**SEATTLE DEPARTMENT OF TRANSPORTATION
FAIRVIEW AVE. NORTH BRIDGE REPLACEMENT
VALUE ENGINEERING
17 OCTOBER 2014**

This Value Engineering (VE) report is presented to Seattle Department of Transportation and the Pertteet / HNTB team to assist in decision making and completion of design at the 60% design stage. The purpose of the study was to review the current documents and offer constructability and VE refinements that can assist in the advancement of the project and reduce risk.

Seattle Department of Transportation
Fairview Avenue Bridge VE Construction Schedule - Fairview Ave N Closure

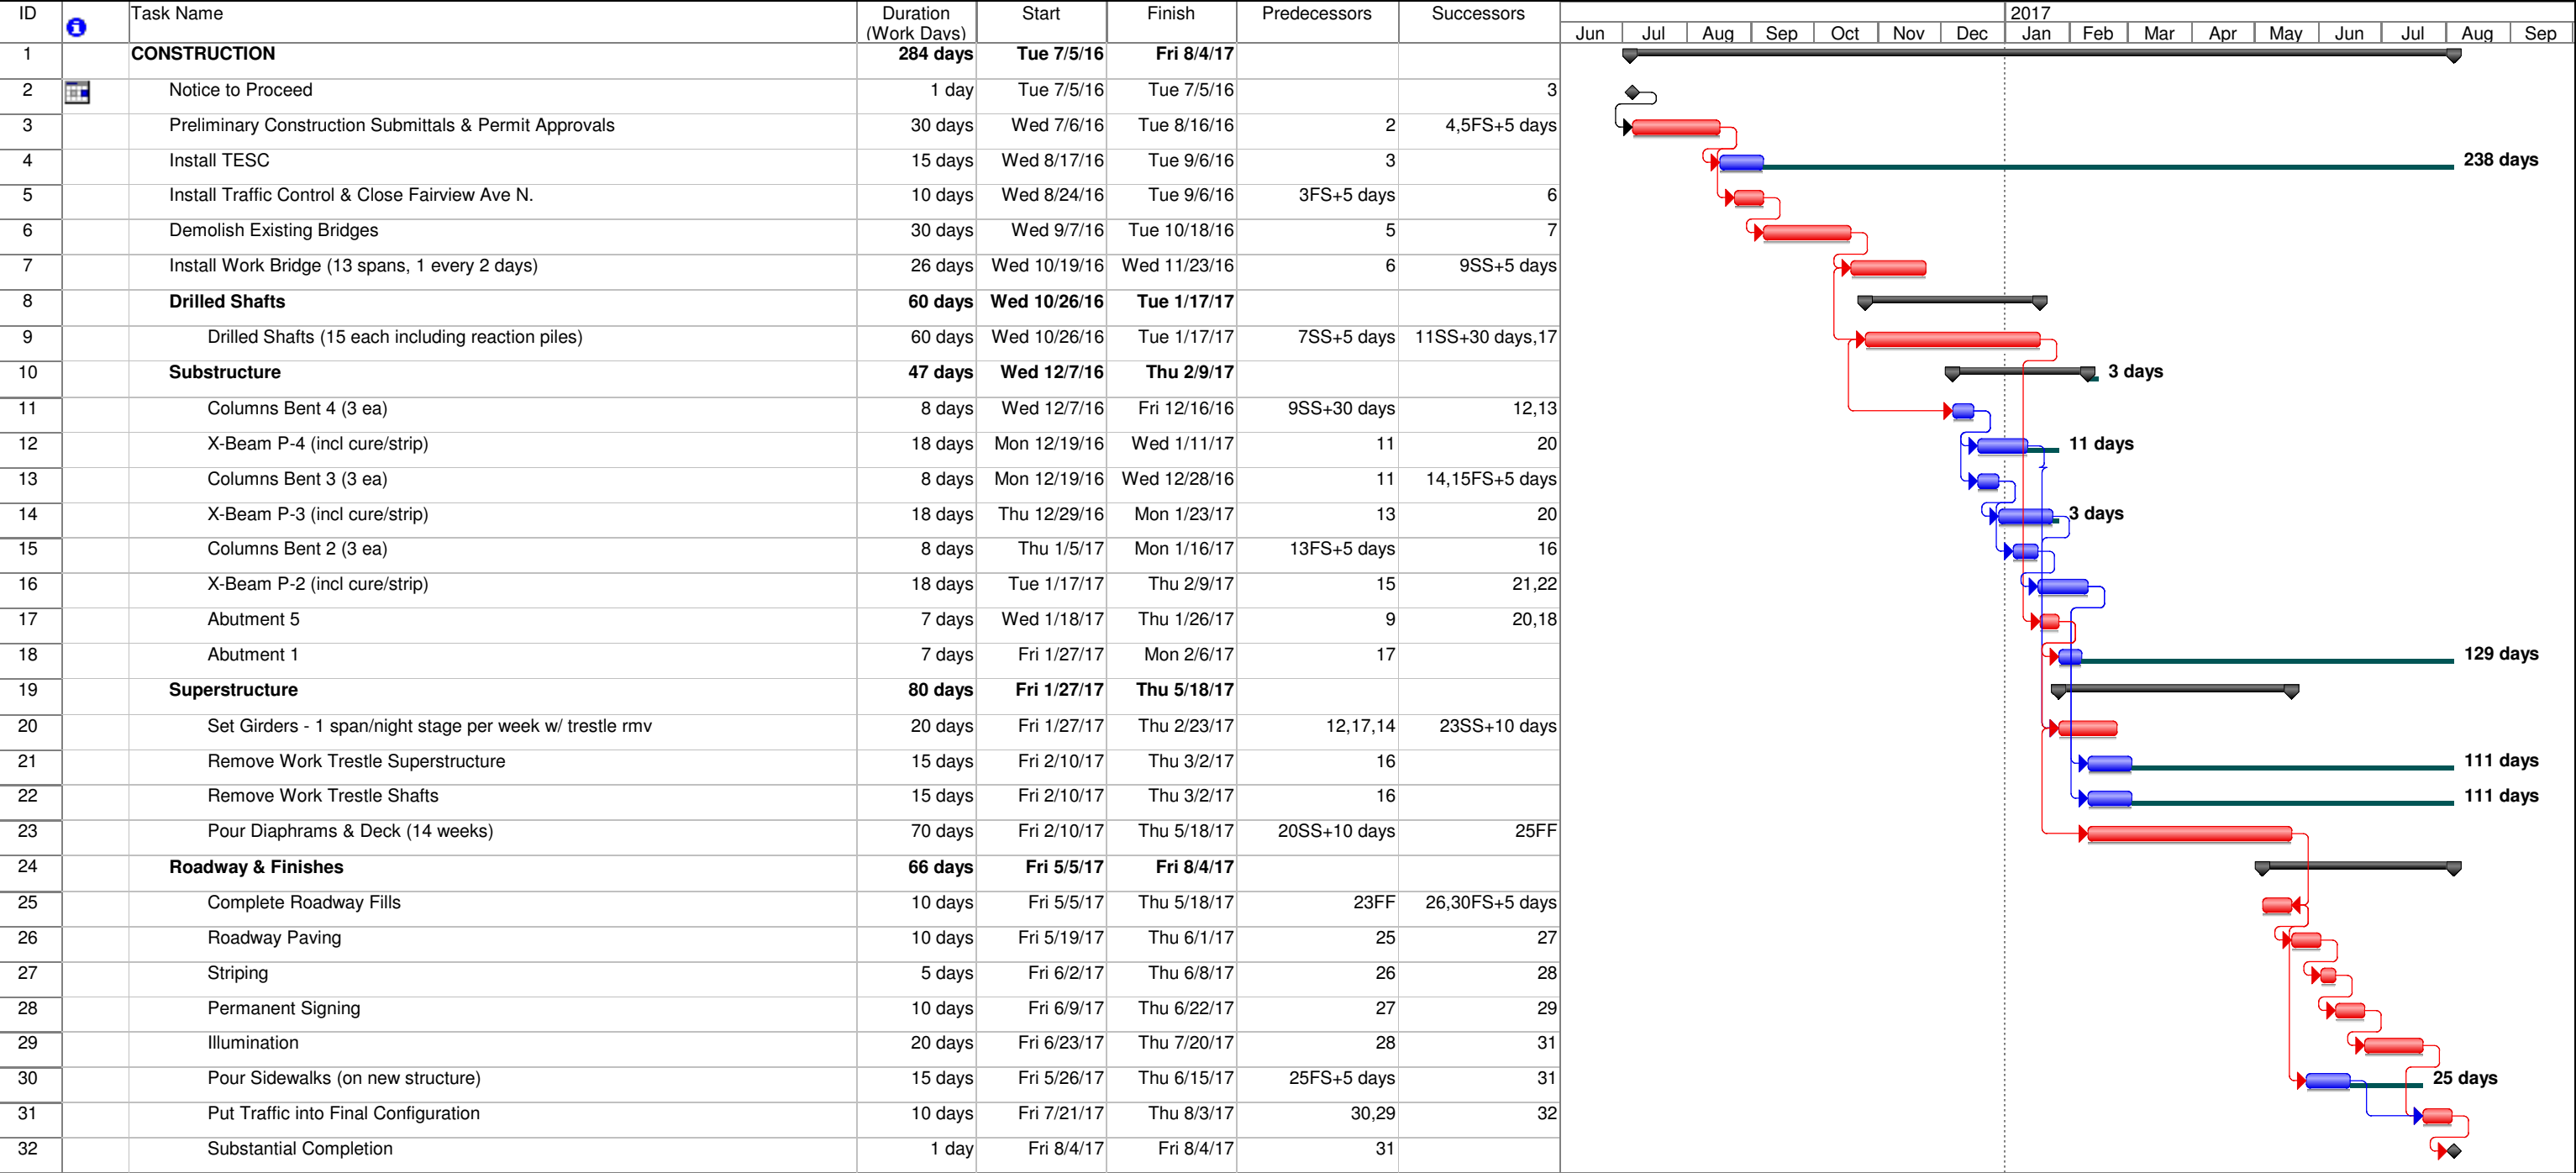
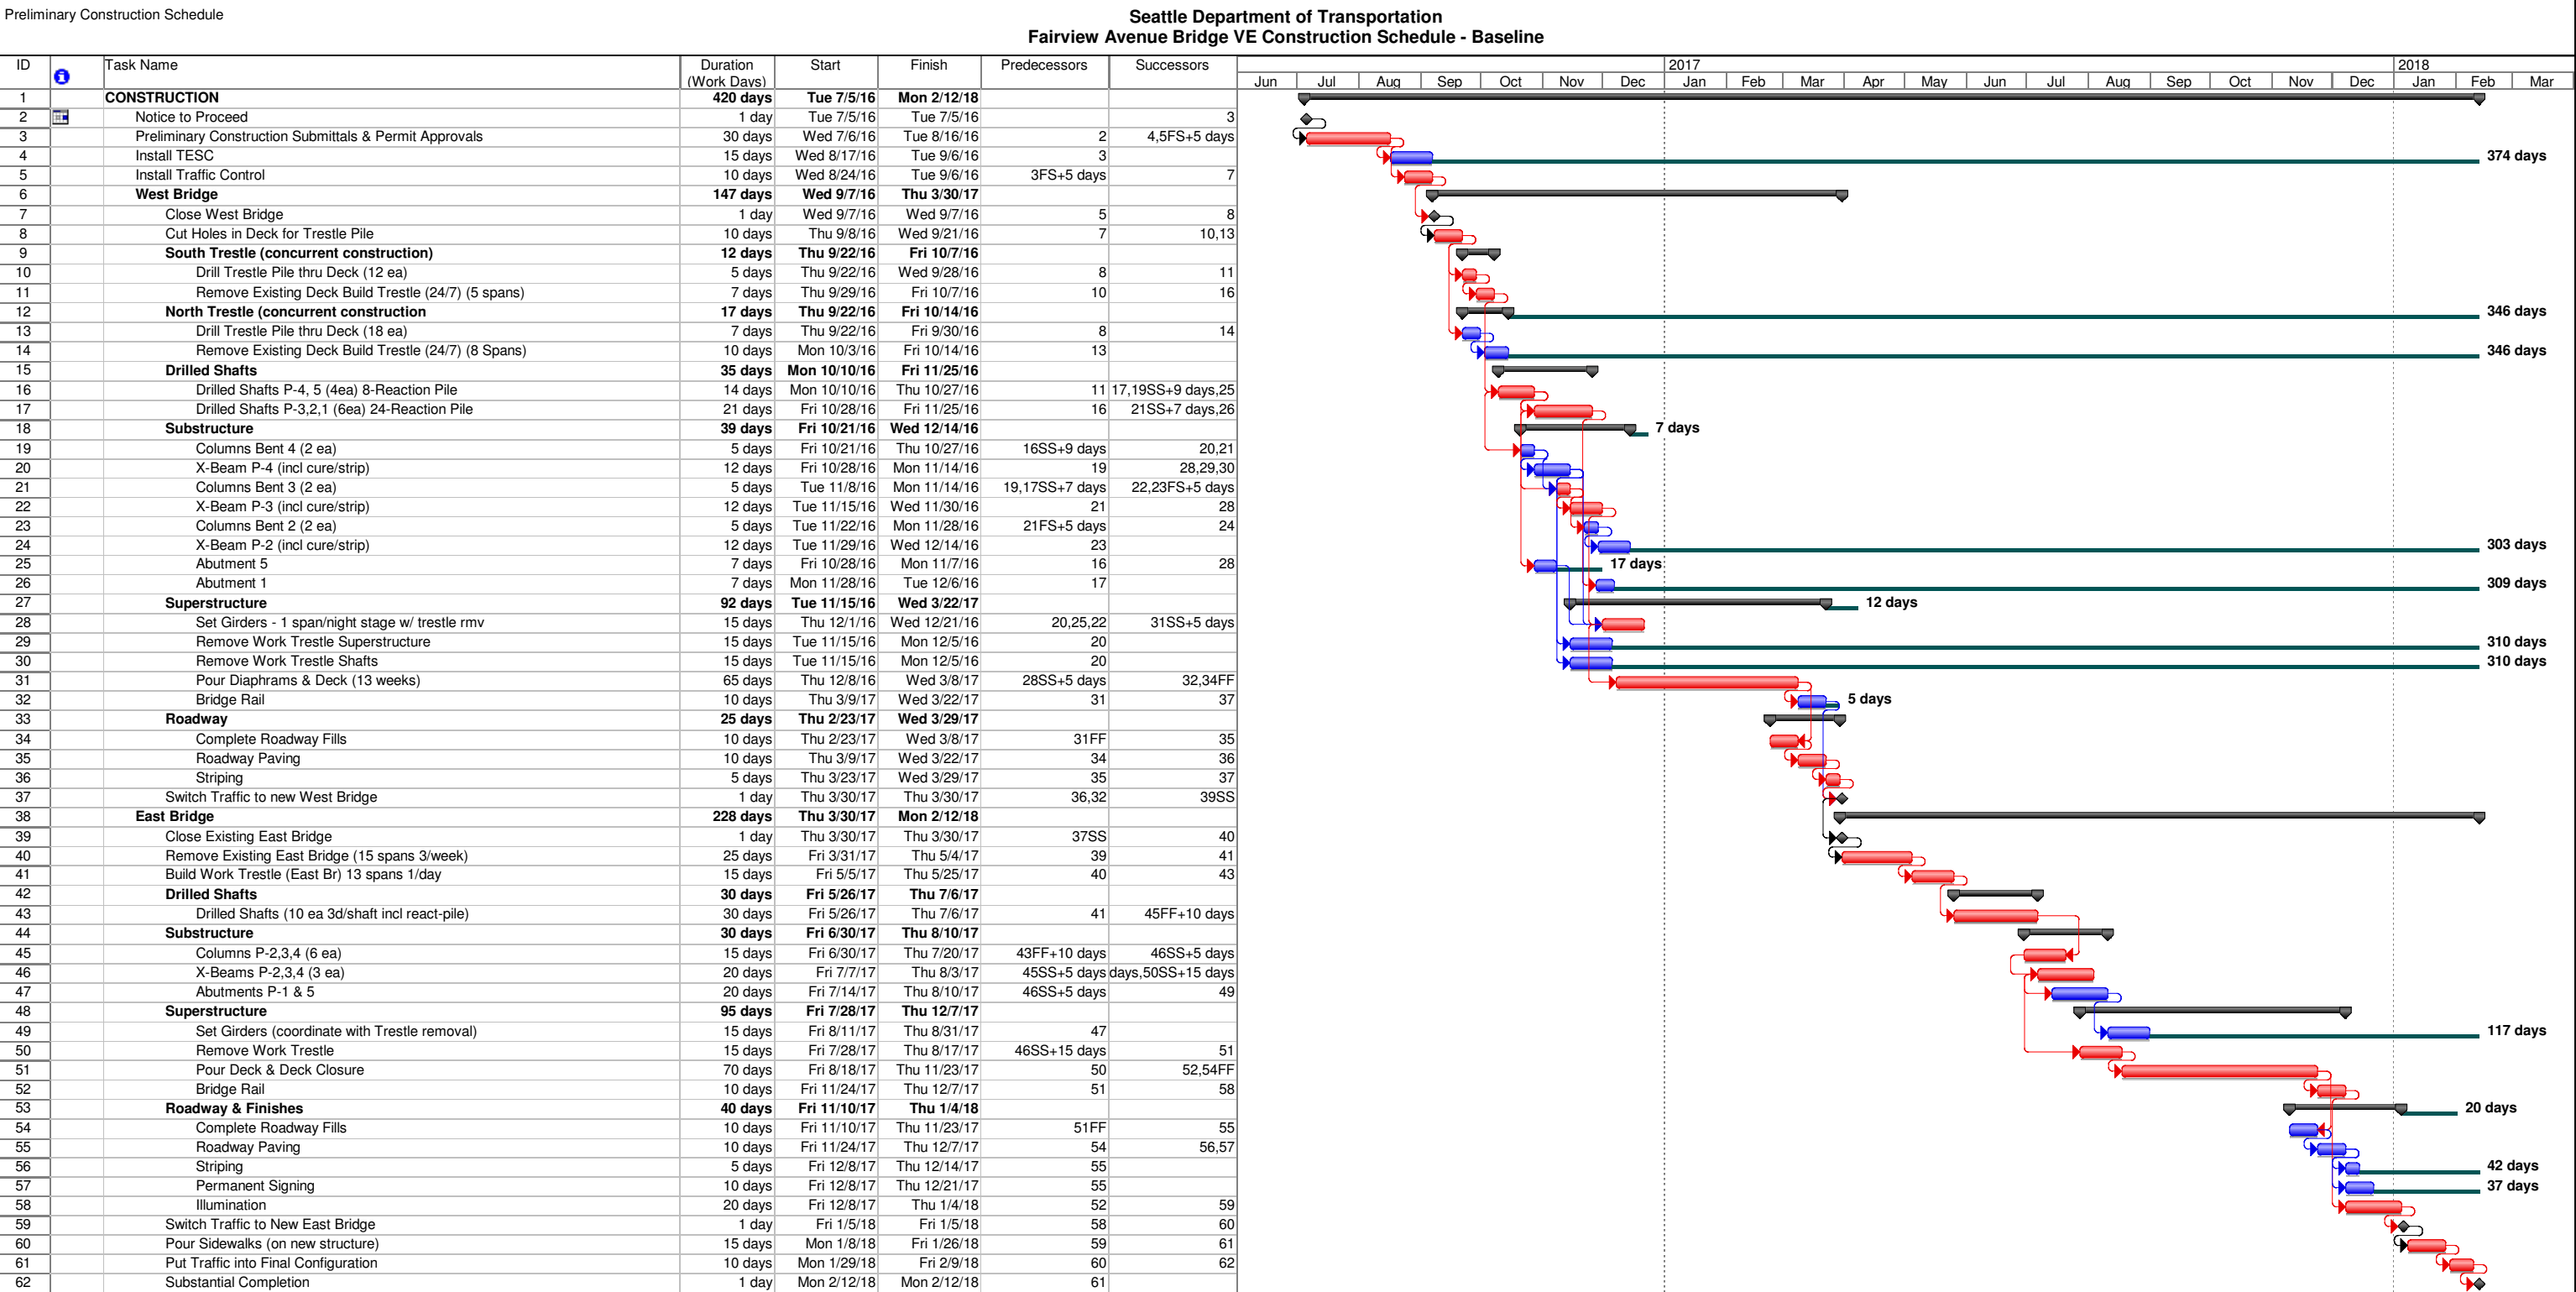
TECHNICAL REPORT	PROPOSAL	T4
COMPONENT: Construction Schedule	AUTHOR	RC
<p>CURRENT CONCEPT: The preliminary construction schedule provided to the VE team for review identifies a total construction duration of approximately 20 months. This duration is based on the construction staging sequence outlined in the current 60% plans that initially places single lane two-way traffic on the east bridge to allow for demolition and reconstruction of the west bridge, followed by shifting of single lane two-way traffic over the new west bridge to allow for demolition and reconstruction of the east bridge.</p>		
<p>CONSIDERATIONS:</p> <p>In summary, the construction schedule provided for review includes major project activities that will drive the critical path under the current construction staging sequence. These major activities also include some detail regarding estimated means and methods, quantities and productivity rate assumptions. Based on a general review of these activities, along with their estimated means and methods and productivity rates, the overall schedule duration of approximately 20 months appears to be reasonable. Additional schedule detail is warranted at this point in the design to further validate this duration and to identify all of the relationships and interdependencies between the various activities. Consider the following to support the further development of the construction schedule:</p> <ul style="list-style-type: none"> • Recommend developing the construction schedule in Microsoft Project (or other scheduling software). This will facilitate the development of a more detailed construction schedule as the design advances and will allow for activity relationships and interdependencies to be more clearly established. This format will also coincide with current design schedule format and will enable the team to have one comprehensive master schedule that defines the entire project from current state to completion. (A sample construction schedule in Microsoft Project based on the excel schedule is provided for the team's use, if desired.) • Confirm that sufficient time is identified up front after construction contract award to allow for critical construction submittal development/review/approval and permit approval. 45 days appears to be the current window of time in the schedule, which may not be sufficient time depending on the number of upfront submittal and permit approvals the contractor is required to obtain prior to starting work.

TECHNICAL REPORT	PROPOSAL	T4
COMPONENT: Construction Schedule	AUTHOR	RC
<ul style="list-style-type: none"> • The design team has a detailed design schedule that identifies the various environmental permits and approval required for the project. Recommend reconfirming the timelines for these various permits and approvals given the current status of the project. • Recommend confirming that in-water work will be allowed to take place outside of the In-Water Work Window. The current construction schedule identifies bridge demolition and shaft construction activities taking place outside of the In-Water Work Window. • For drilled shaft construction, consider adding at least one more work day per shaft to account for the various constraints associated with these shafts (depth of 140-ft, construction from work deck, reaction pile installation, mob/demob, permanent casing, likelihood of obstructions, night work and site constraint limitations). This would result in an additional month of construction duration, assuming all drilled shafts fall on the critical path. • Recommend adding third party utility relocations into the overall program schedule. Assuming these relocations will be coordinated by the City and executed by the third party, this work should be scheduled to take place prior to award of the construction contract in order to sufficiently mitigate the City's risk. • Recommend including additional detail to the construction schedule to coincide with the current state of the design. Activity productivity assumptions should coincide with the cost estimate. Consider further the development of a cost loaded schedule that will provide the City with anticipated expenditures throughout the duration of the project. • Consider adding critical path schedule contingency to cover unforeseen delays associated with subsurface obstructions. This time contingency would coincide with the contingency in the estimate set aside to cover the cost (Removing Shaft Obstructions [619908]). Recommend 30 days. • The primary opportunity for improving the construction schedule appears to be the full closure of Fairview Ave N to allow access to both bridges at the same time. Please see proposal P6a for more detail on this benefits of this concept. By implementing this concept, the project schedule could be reduced in schedule by up to 12 months. See the attached schedule outlining a conceptual approach to completing the work with a full closure of Fairview Ave N.
